CROSS ALAMEDA TRAIL JEAN SWEENEY IMPROVEMENTS

FEDERAL-AID PROJECT NUMBER ATPL-5014(042)

PROJECT NUMBER P.W. 05-16-11

ADDENDUM NO. 03

TITLE : BENCH ASSEMBLY
 PATENT D467-101

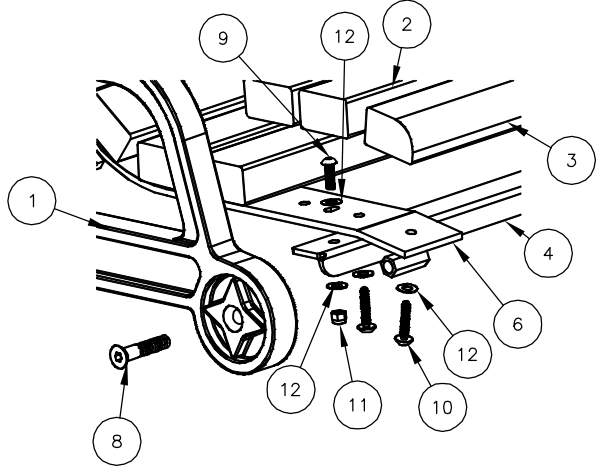
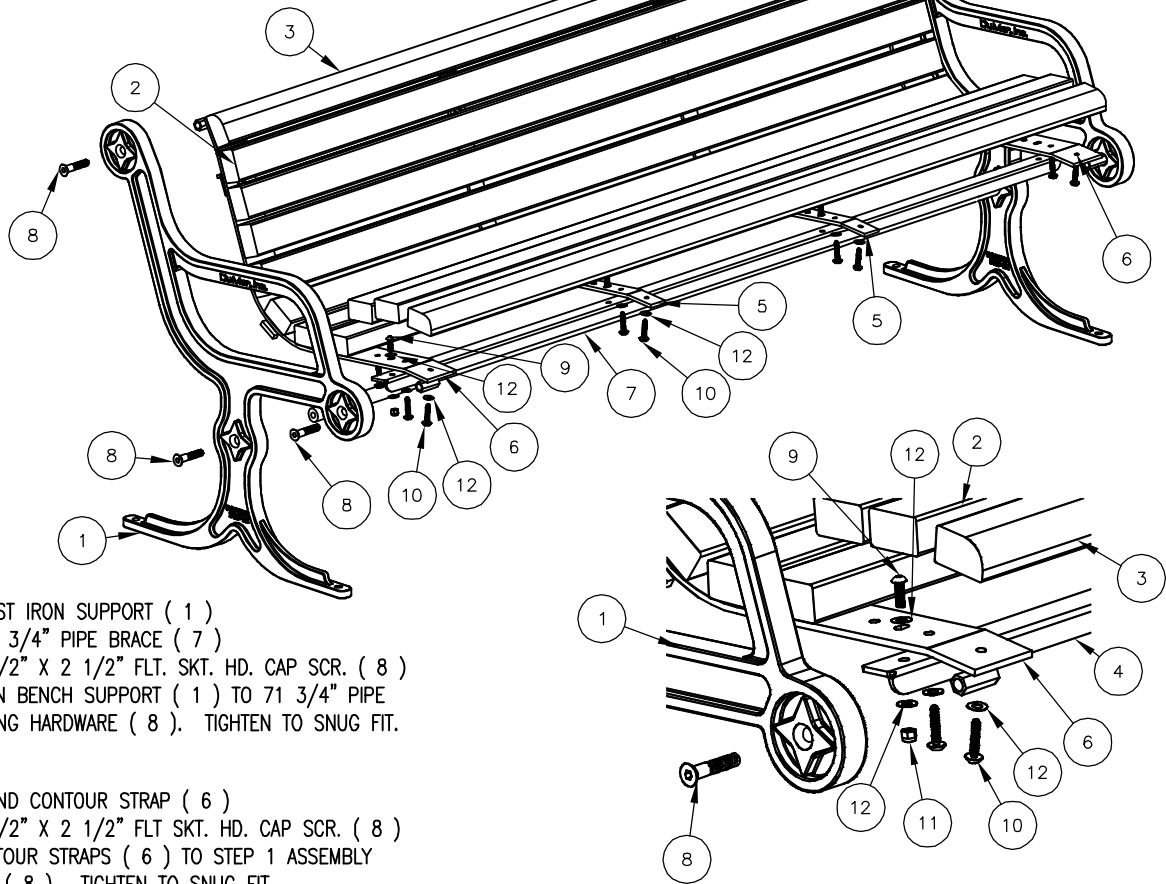
4) Per item 10.55 Benches (both concrete and metal), SECTION 10 – SPECIAL PROVISIONS; "Benches shall be provided by the City and assembled and installed by Contractor". Please provide assembly instructions and weights.

b) For METAL BENCH: MFR.: DUMOR, MODEL: Bench 142-60PL, IPE WOOD, with green metal, Surface Mounted, wt.; 211 lbs, assembly required (instructions attached).
